Solicitation Addendum

Addendum No.: 3
Solicitation No.: 26-R089352DJ
Solicitation Title: Bishop Point Living Shoreline
Addendum Date: March 10, 2026
Procurement Contact: Dave Janney

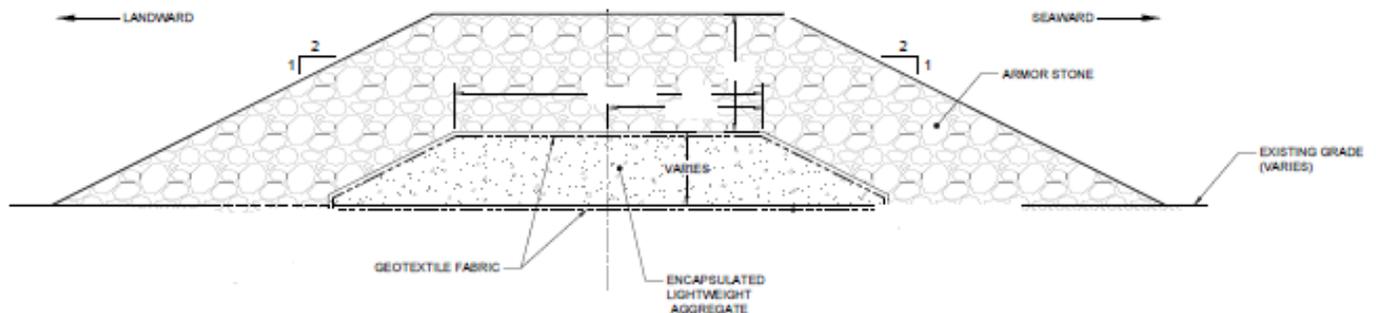
Q1. I don't see a riprap cross-section detail. Is fabric being installed under any construction areas?

R1. The riprap cross section are shown on C-301 and C-302. The riprap shall be placed with a minimum of 2 horizontal to 1 vertical side slopes in the areas outside the designed littoral shelf with crushed stone wrapped in geotextile fabric to allow for a stable base to build upon. See below for typical cross section:

Map of Boundary and Topographic Survey
of
Bishop Point
Located in
Section 19, Township 34 South, Range 17 East
Manatee County, Florida

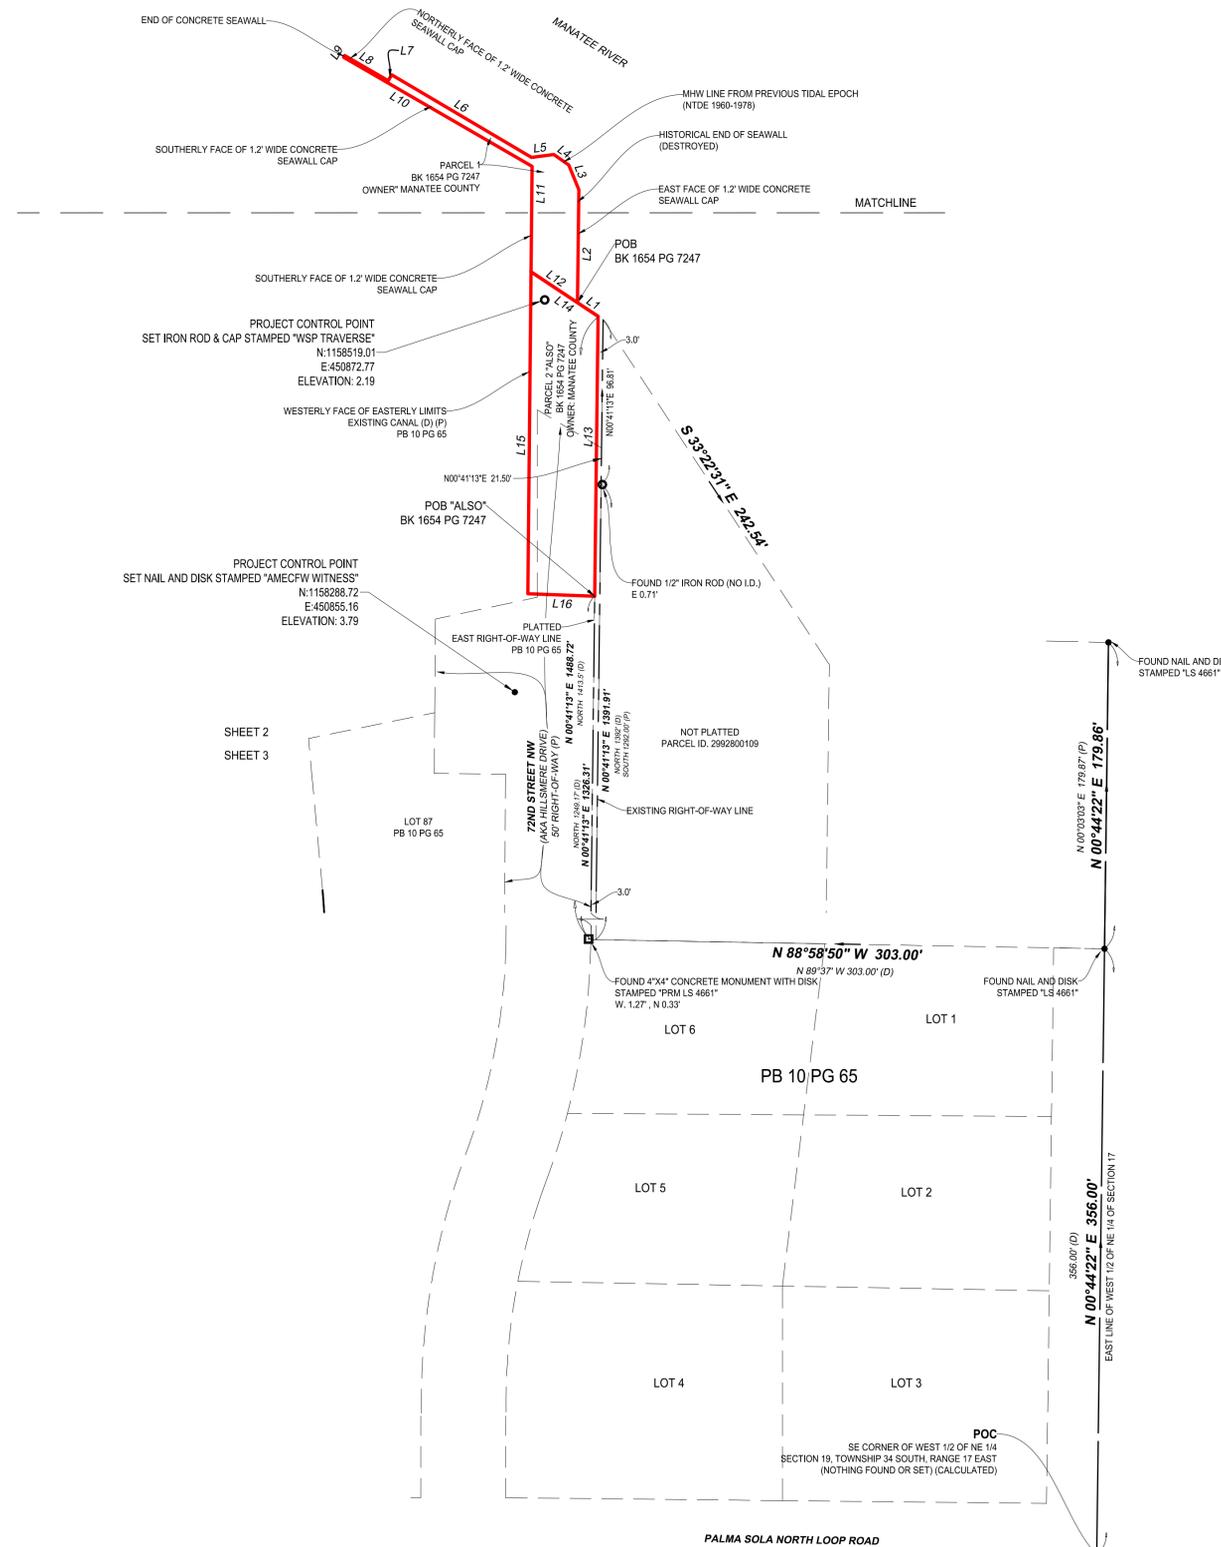
Q5. Do you have surveys showing the water depths around the areas where Reefballs will be installed?

R5. Yes, see attached for reference and also part of the plans.
